FOUNDATION INVESTIGATION REPORT
For
Proposed Structure at the Crossing of
Wye River and Hwy. #27
Township of Flos - County of Simcoe
District No. 5 (Owen Sound)
W.O. 70-11069 -- W.P. 282-66-00
CONT 72-025 site 30-57

FOUNDATION INVESTIGATION REPORT
For
Proposed Structure at the Crossing of
Wye River and Hwy. #27
Township of Flos - County of Simcoe
District No. 5 (Owen Sound)
W.O. 70-11069 -- W.P. 282-66-00

Wye River Bridge - Site #30-57,
2.4 Miles North of Hwy. #92,
Hwy. #27, Dist. #5 (Owen Sound),
W.P. 28-66-00 -- W.O. 70-11069

Aye River Bridge - Bridge Site 30-57
2.4 Miles North of Hwy. #92 in Elmvale
Hwy. #27 - W.P. 282-66-00 - W.O. 70-11069
District No. 5 (Owen Sound)

DRAWING NO. 70-11069 B

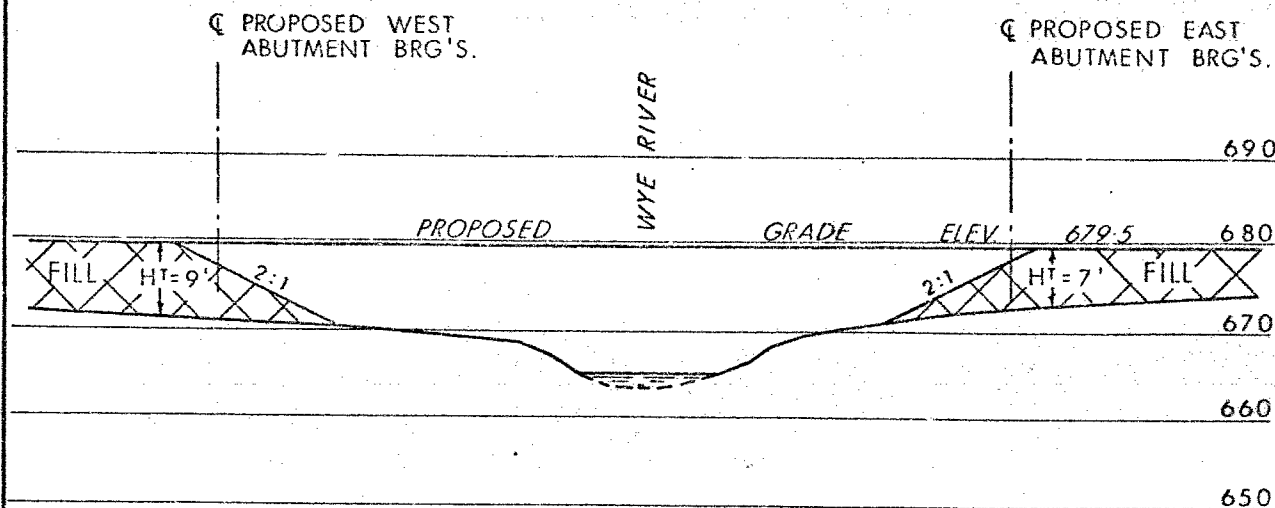
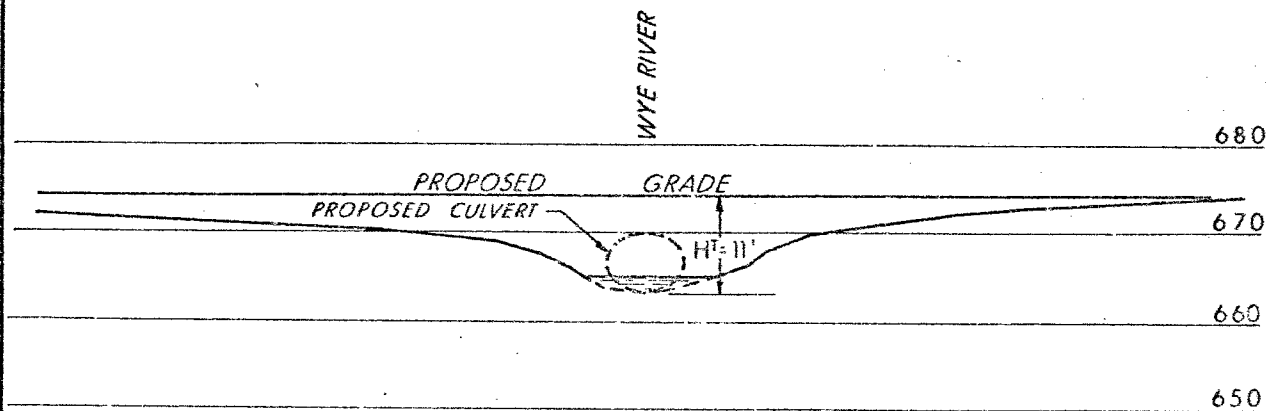
If a Bailey Bridge scheme is considered for the detour at this location, the fill heights to be restricted to 7 ft. and 9 ft. above the ground at East and West Abutment locations, respectively (Ref. Dwg. 70-11069B), in order to ensure stability in the longitudinal direction. The aforementioned fill heights are based on the assumption that the proposed grade will be at elev. 679.5.

A detour incorporating a multi-plate pipe arch may be considered at this location. In order to ensure stability in the longitudinal and transverse direction, the fill heights, with standard 2:1 slopes, should not extend beyond 11 ft. above the river bed or natural ground surface. This will restrict the proposed detour grade to elev. 674.0. However, higher detour grades may be possible, but berms will be required on either side of the roadway in the transverse direction. If the detour grade has to be maintained at elev. 679.5, a transverse mid-height berm of 20 ft. will be required on either side of the detour roadway for a maximum fill height of 16.5 ft.
